## 7. REVISED PLACE BASED PLAN

# CROSKELL Precinct Structure Plan

Co-Design Workshop Summary Report

October 2022 *Version 2*

FIGURE 12: ORIGINAL PLACE BASED CONCEPT PLAN

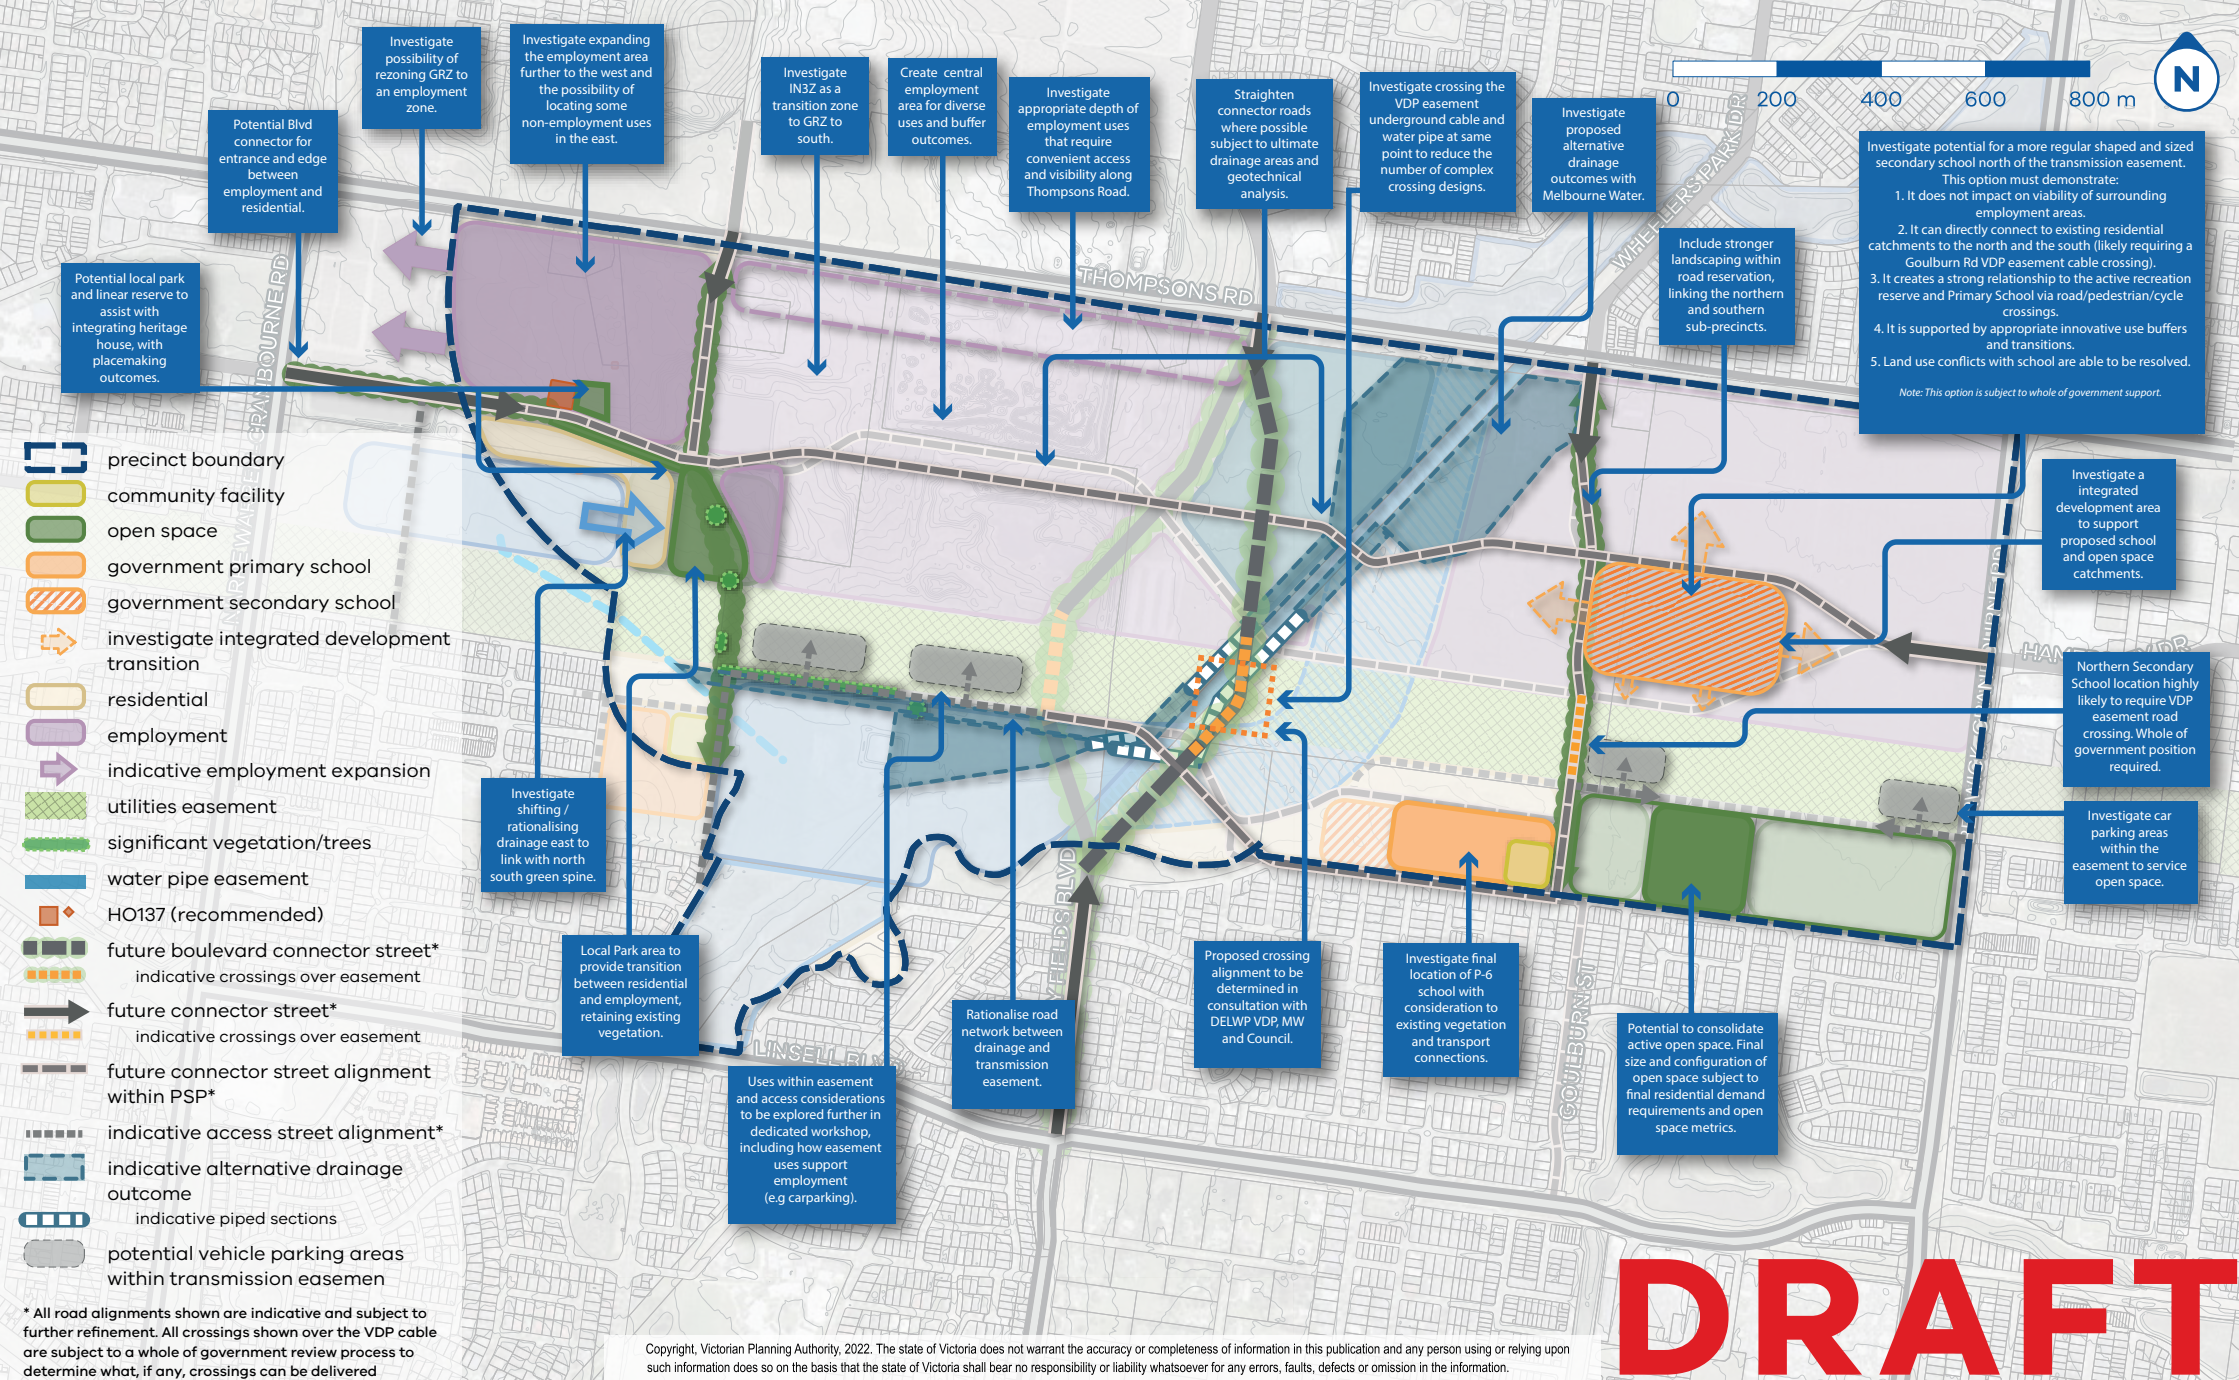
*"Combining the wetland with reserve means the drainage outlet can be located within the linear reserve traverse across the easement."*

*"Parcel 16 does not support potential school extension in the west of the site. The entire parcel 16 must be set aside as residential. All Schools to be north of the utilities easement."*

*"Straighten out kink in Casey Fields Blvd to maximise efficient superlot outcomes"*

*"Need to show mixed-use/residential surrounding the newly located secondary school site."*

*"Do not support relocation of the Active Open Space from Parcel 19 to 16. This is inequitable and needs to be adjusted."*

*"The existence of each and every crossing over the easement needs to be justified and approved."*

*"This is a business with residential PSP that has missed a vital opportunity to provide higher density residential. Having a school in an employment area isn't appropriate."*

*"Medium density residential (townhouse, low apartments) are encouraged to face school and waterway."*

FIGURE 14: REVISED PLACE BASED PLAN - DAY 2 WORKSHOP COMMENTS

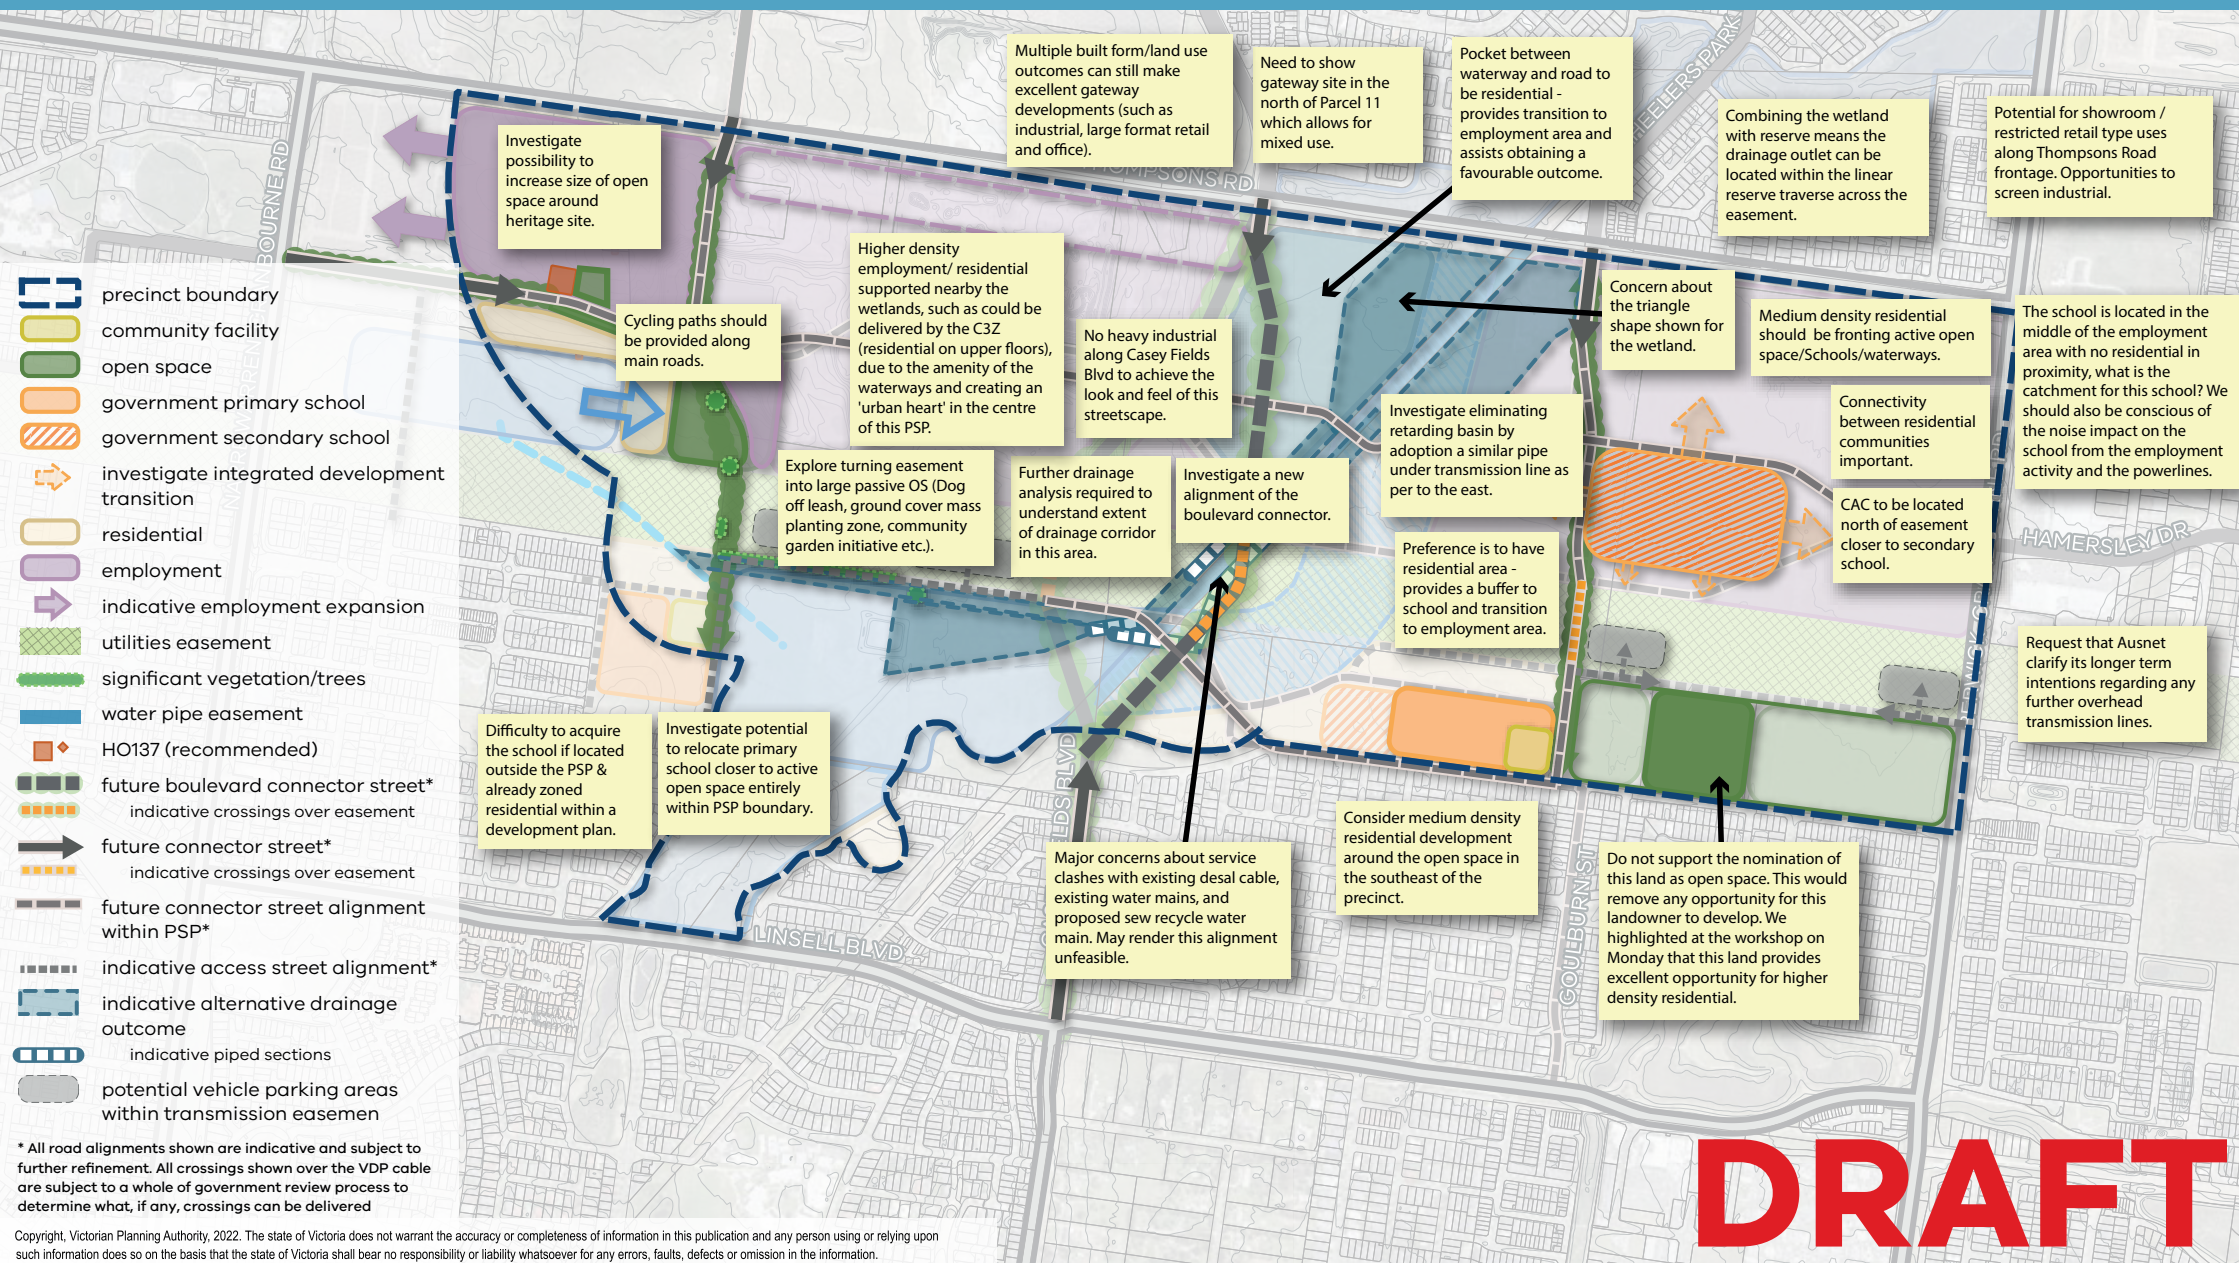
Overall, there was **general acceptance** from participants of the revised Place Based Plan, with many participants dropping 'thumbs up' on key changes from day 1.

Additional consideration was given to **buffer and interface** treatments for the proposed employment land adjoining Thompsons Road to reduce any impacts on existing residential areas to the north.

Opportunities to investigate further consolidation of waterway and drainage assets continued to be a primary topic of discussion. There was a **strong preference** to reduce the size of retention basins to optimise employment land provision.

Participants considered how non-sensitive uses surrounding the revised school site could interface with school-based vehicle and pedestrian traffic acknowledging the ongoing need to **separate employment and residential traffic**.
